I made quite some progress:

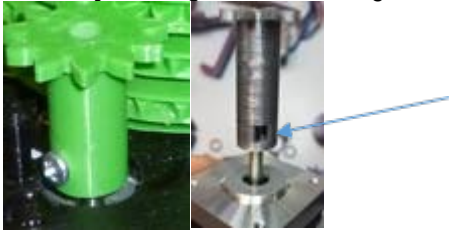
- Had to cut screws since countersink will cause them to break. Probably difference from stepper to stepper.
- Gears A,B,C on your picture is shown screw but on latest version is a square hole. Not sure how did you imagine to lock the gears on stepper shaft

- Extruder :

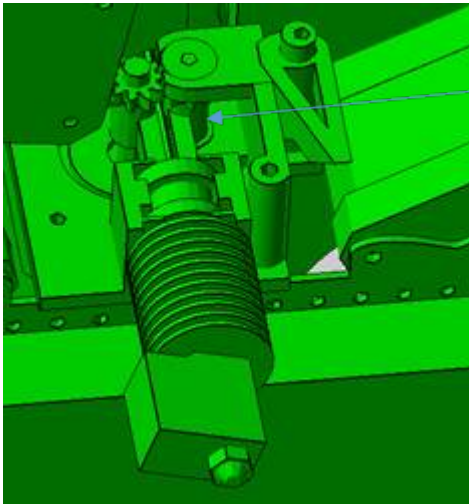
On below picture the extruder gear have longer shaft but on last version the gears are thin and no shaft. I believe few parts are missing.
